REMARKS

This amendment is responsive to the non-final Office Action mailed on November 10, 2005. Claims 1-14 and 19-23 are pending and claims 1, 2, 4, and 6 have been amended. Claims 3, 10-11, 19-21, and 23 have been cancelled. In view of the foregoing amendment, as well as the following remarks, Applicants respectfully submit that this application is in complete condition for allowance and request reconsideration of the application in this regard.

Amendments to the Drawings:

Annotated Sheet Showing Changes

FIG. 1
PRIOR ART

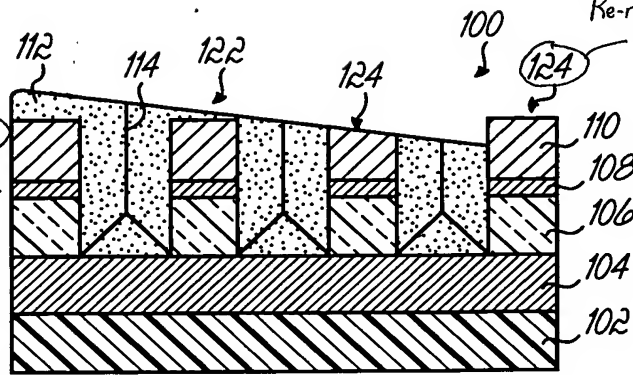
Applicants have amended the drawings to correct minor labeling errors in Fig. 1. In Fig. 1, one occurrence of reference numeral 122 has been revised to read reference numeral 120, one occurrence of reference numeral 124 has been revised to read reference numeral 126, and a "Prior Art" designation has been added. Applicants have also modified the written description so that the description of Fig. 1 more accurately conforms to the drawing of Fig. 1. Applicants submit that no "new matter" has been introduced into the specification by these amendments.

The attached sheet of drawings includes a change to Fig. 1. The sheet, which includes Figs. 1-4, replaces the original sheet including Figs. 1-4. In Figure 1, two reference numerals have been revised and a "Prior Art" designation has been added.

Re-numbered
as 120

Re-numbered as
126
